Enclosure 1
Responses to NRC Request for Additional Information, RAI No. 253

Questions 03.07.02-42, 43, 44, 47, 48, 52, and 53

Calvert Cliffs Nuclear Power Plant, Unit 3

Figure 13

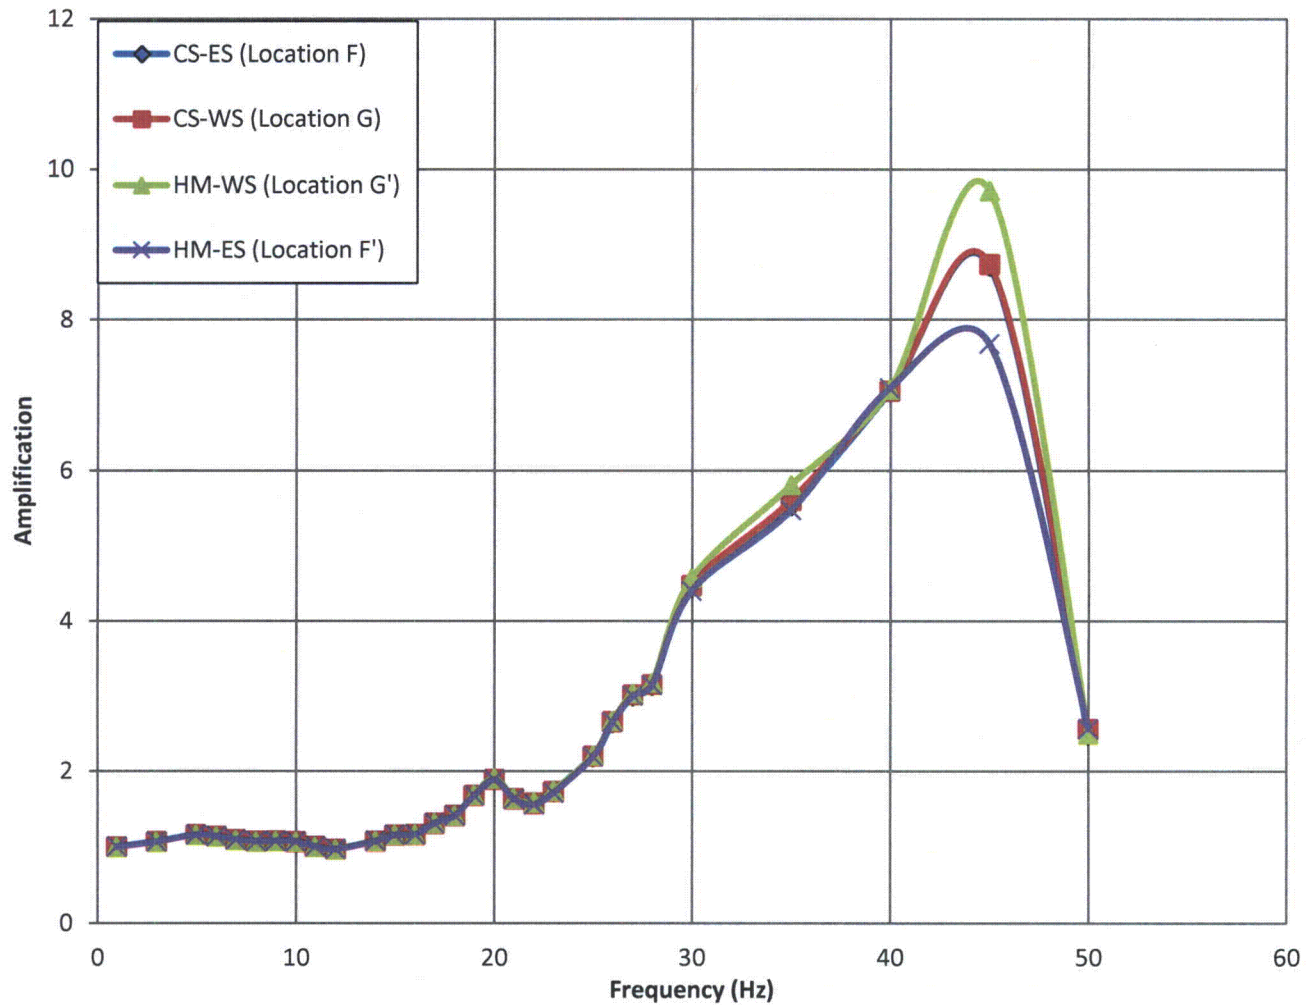
The seismic model of the UHS EB assumes that the building is symmetric along the North South plane of the structure. However, the internal walls are not symmetric about this plane (See Figure 3E.4-5 in Revision 6 of the FSAR). For a seismic excitation in the North-South direction, there will be a torsional response of the structure which the existing model locks out due to the assumed boundary conditions. The applicant is requested to address why this non symmetry was ignored in the model development and what affect the modeling assumptions have on the building's seismic response and the computed torsional loads for which the structure must be designed. The staff requests this information to enable it to determine whether or not the response of the structure to a seismic event and the loads used in structure's design have been under-predicted by the assumption of building symmetry.

Figures 8 and 9 show the comparison of the amplification function in the X (N-S) direction. Figures 10 and 11 show the comparison of the amplification function in the Y (E-W) direction. Figures 12 and 13 show the comparison of the amplification function in the Z (vert.) direction.

Vertical (Z) direction amplification functions for points located on a floor at Elevation 26.5 ft in the UHS MWIS for complete structure East Side(CS-ES) at location F, complete structure west side (CS-WS) at location G, half Model on West Side (HM-WS) at location G' and Half Model on the East Side (HM-ES) at location F'.

Based on the amplification function results, the complete structure (CS), the half model on the east side (HM-ES), and the half model on the west side (HM-WS) show agreement for both X(N-S) and Y(E-W) direction input motions. No significant difference was observed and the effect of non-symmetric features looks negligible for N-S and E-W directions of motion. However, the comparison of the three models for the vertical (Z) input motion shows some differences as shown in Figures 12 and 13. The differences are the result of the non-symmetric features in the UHS MWIS. Both the complete structure (CS) and the half model on the west side (HM-WS) show larger amplification response compared to the eastern side (HM-ES) of the CBIS for frequencies approximately higher than 30 Hz. To account for the effect of this symmetry effect in the UHS MWIS, the western half of the CBIS is selected for further detailed SSI analysis of the CBIS.

Figure 3.7-26—{Isometric View of the Common Basemat Intake Structures and UHS Electrical Building GTSTRUDL Model}

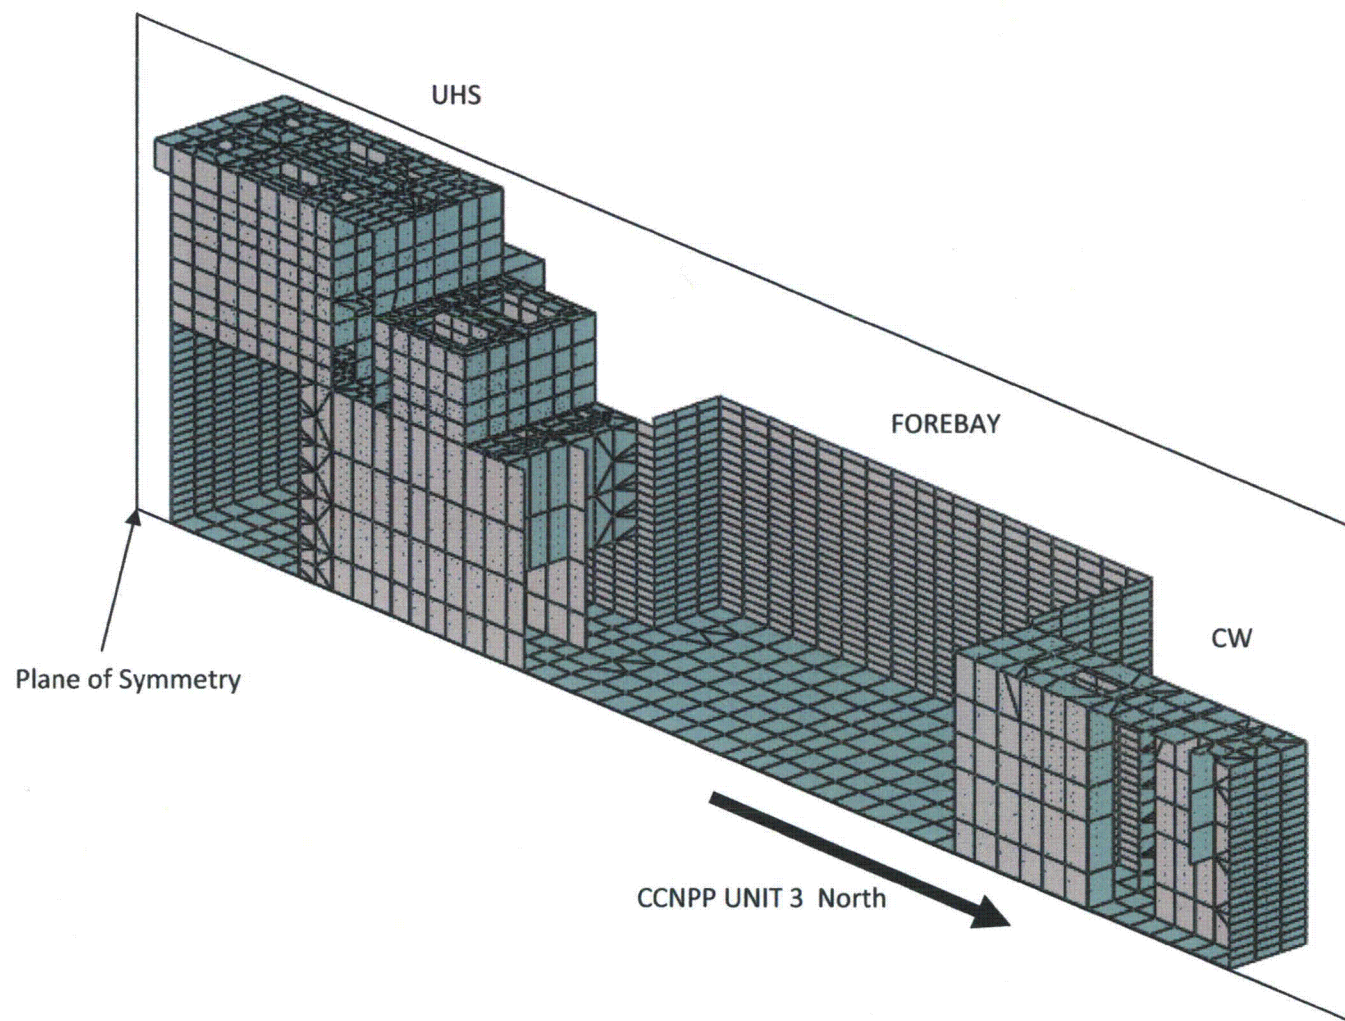
The last sentence in the first paragraph of page 3-38 refers to Figure 3.7.2.3-1 as providing the finite element mesh for the half model of the CBIS. It appears the figure number should be 3.7-26. The applicant is requested to identify the correct figure number and change the reference in the FSAR.

The figure referenced in Section 3.7.2.3.2 has been corrected to identify Figure 3.7-26.
